# Certificate of Appropriateness

**2465 W. Congress Street and 4381 N. 25<sup>th</sup> Street, Garden Homes Historic District**

Replace the framing, posts, rails, decorative cross-buck railing, decking, and stairs on both porches of the duplex to match the design of the historic porches. Balusters cannot be outside mounted to the rails. Treated wood used only for structural framing and not on visible portions of the porch. No work on the porch roofs at this time but future work will be submitted to HPC for approval.

**4/23/2024**

## Basic Railing and Newel Post Design

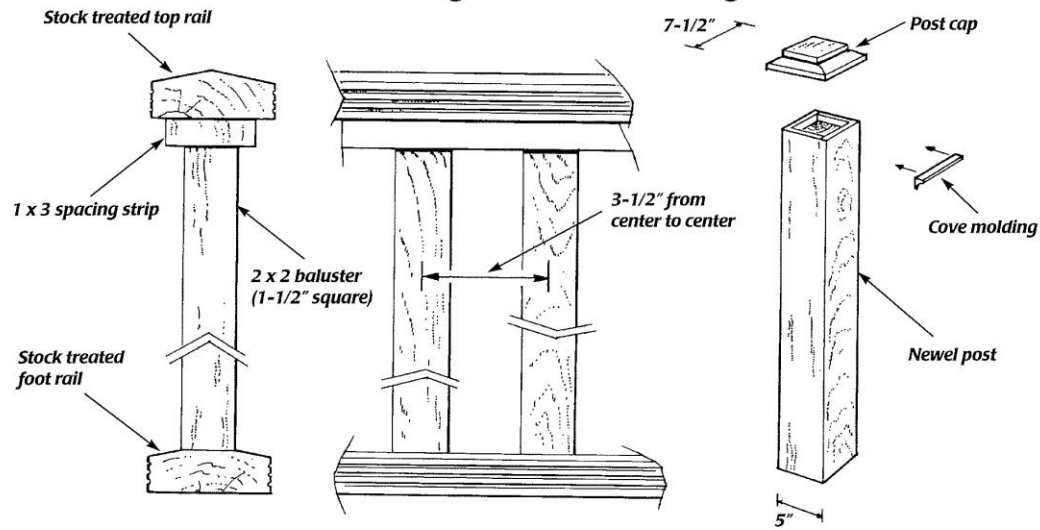
Porch top rail must have profile less than 2x4"
